## Modification of the PA0160 in order to give 24V at the IN1 to IN8

V1.00 - 20150113

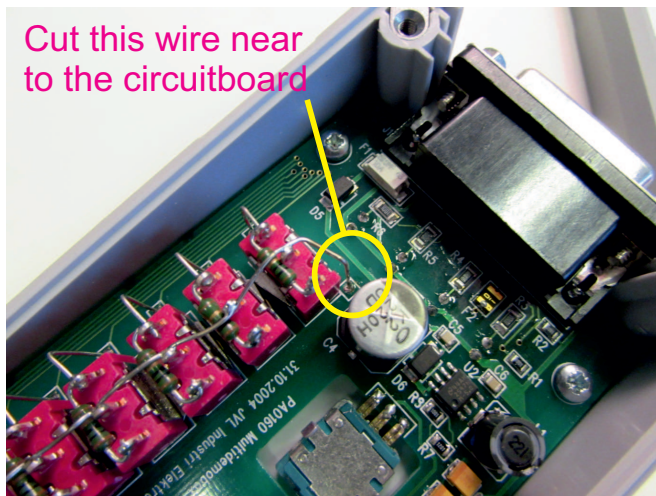
The standard PA0160 only produces 12V at the IN1 to IN8 signals. This is however not enough to activate the inputs at the MIS23x, MIS34x, MIS43x and the modules MAC00-B41 and B42. Below is shown how to change the IN1 to IN8 signals from 12V to 24V which will enable the box to operate with the products mentioned above.

Cut this wire near to the circuitboard

Resolder it to the pin of the diode as shown
